A/TM-LTYT/478

A/TM-LTY/478 回應運輸署的擬問

TPB / A / TM-LTYT / 478 車輛流量評估

**TYPICAL DETAILS
OF RUN-IN
(SHEET 1 OF 2)**

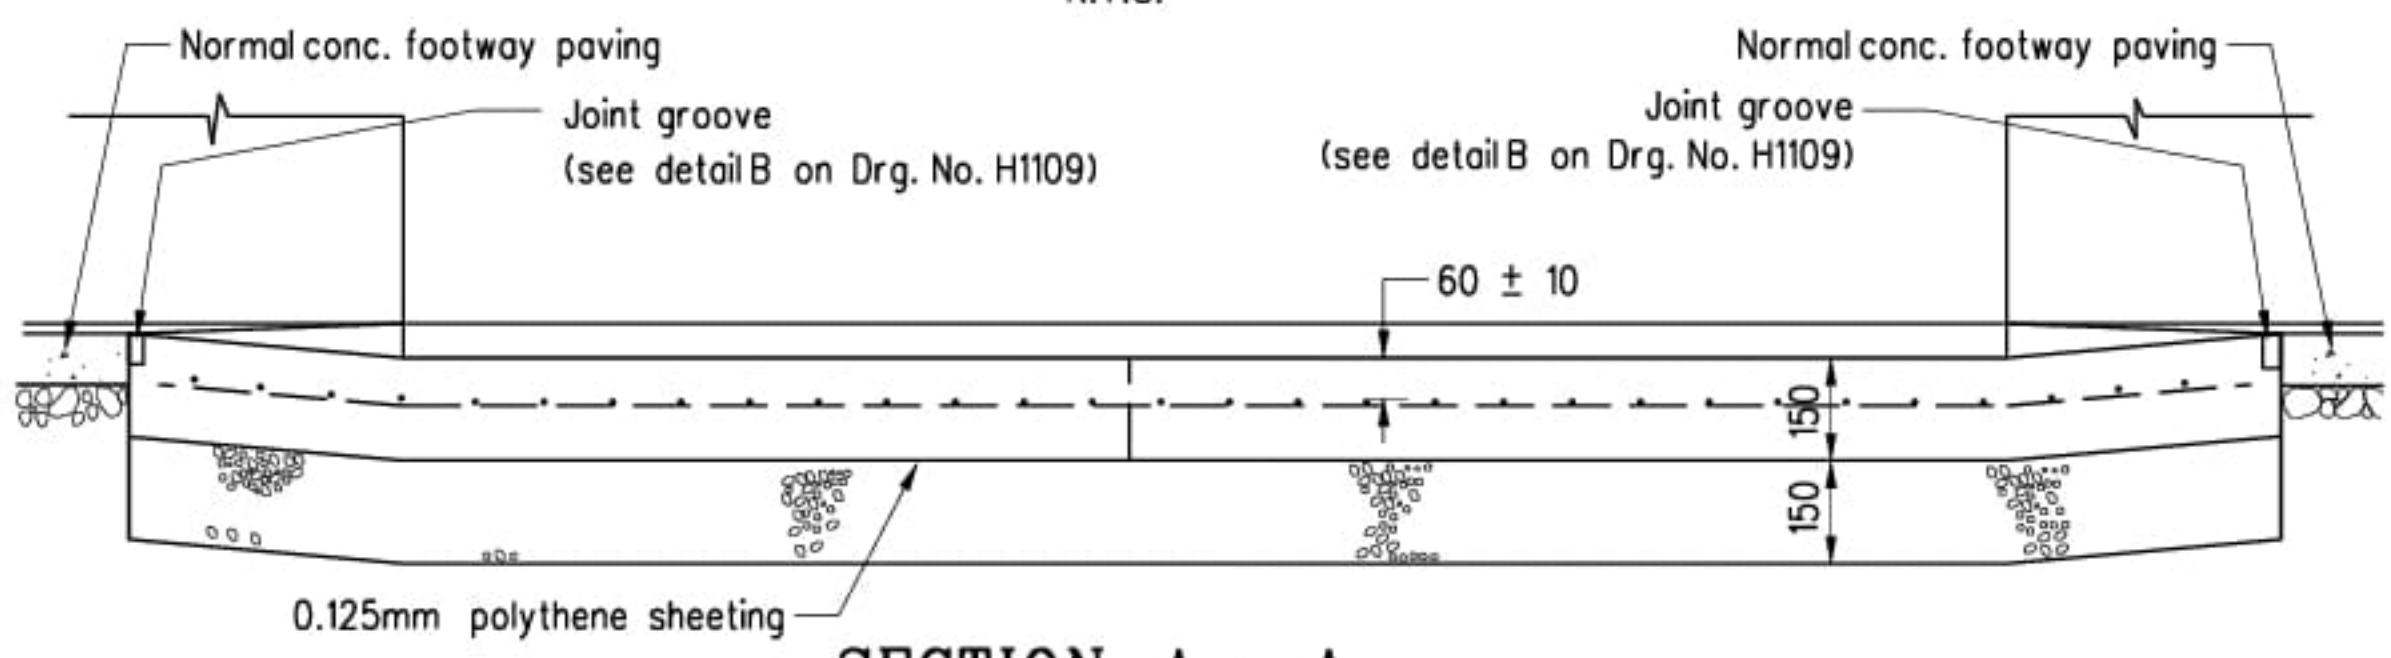
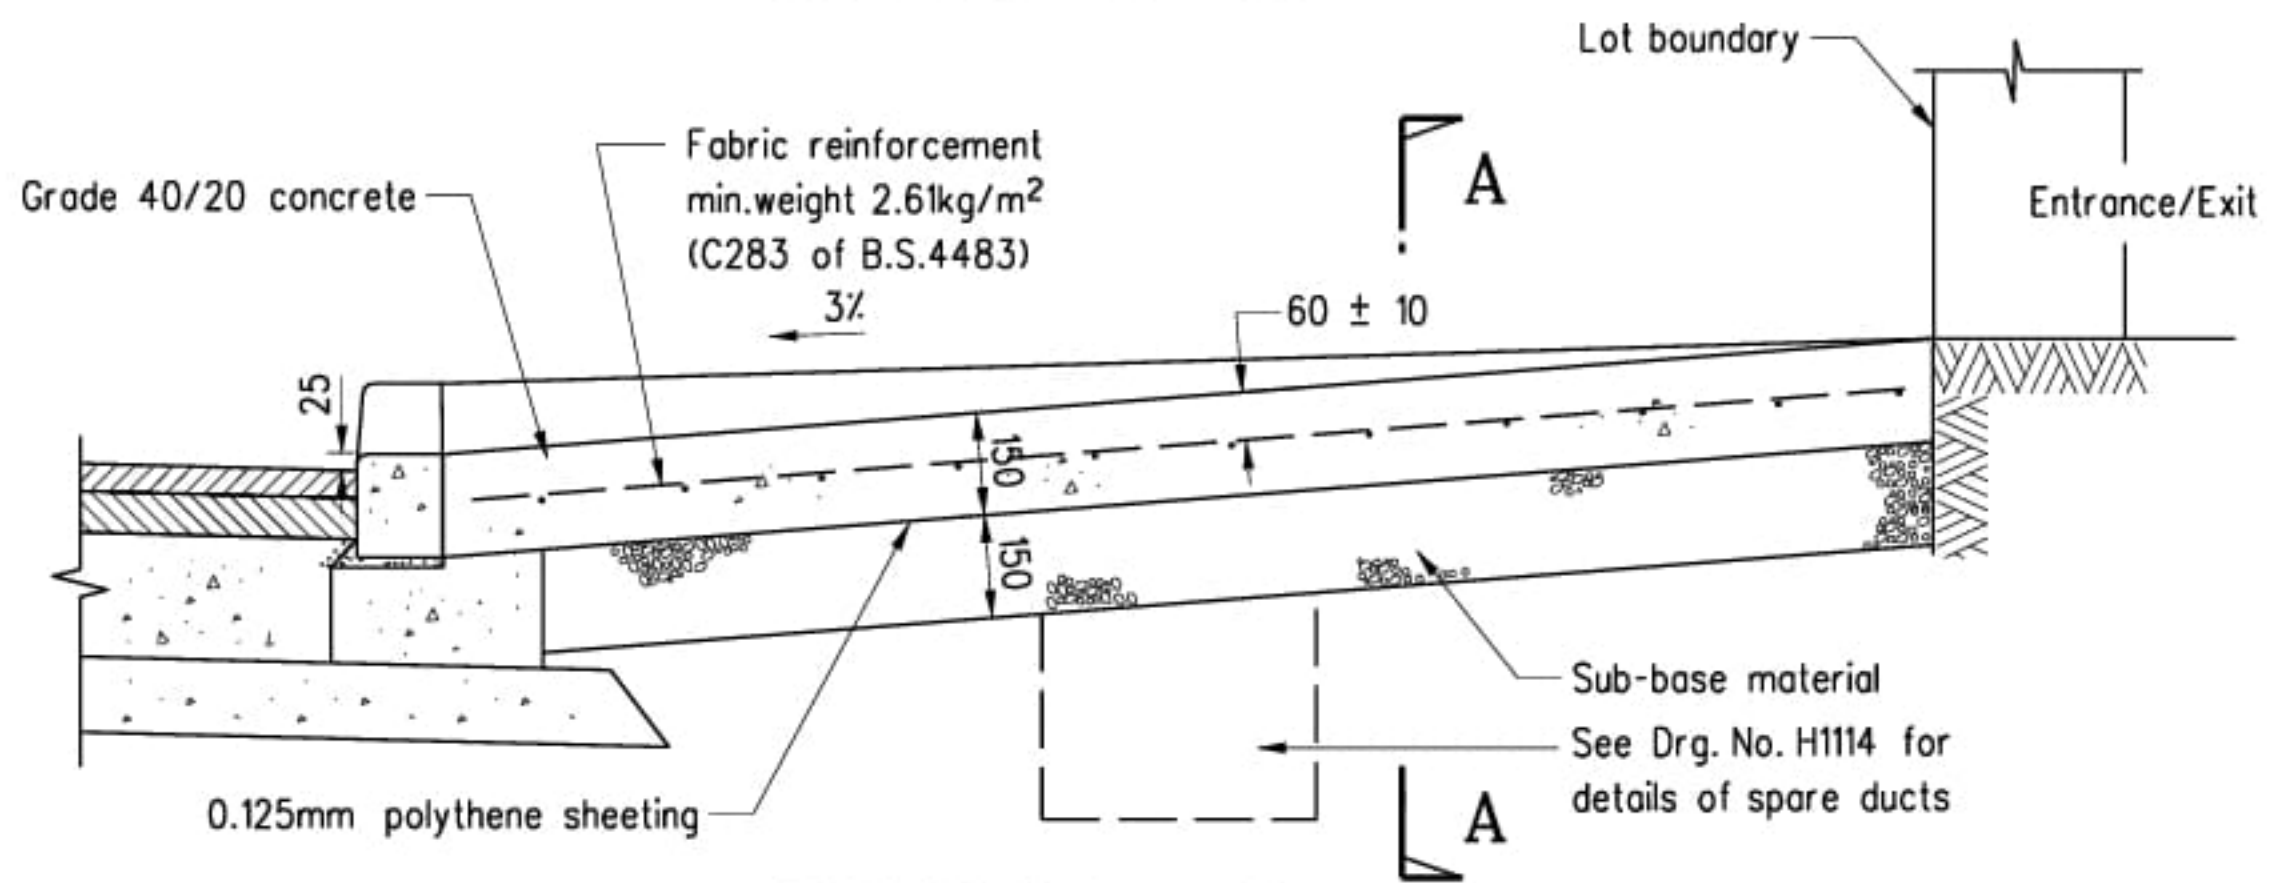
- e. Please clarify if any run-in / run-out will be provided at the public footpath for assessing the site. If affirmative, it should be designed and constructed by the applicant in compliance with HyD's standard and to the satisfaction of HyD.

如獲批准我會向有關部門申請，依照路政署的指引HIGHWAYS DEPARTMENT (H 1113C) 進行改善出入口。
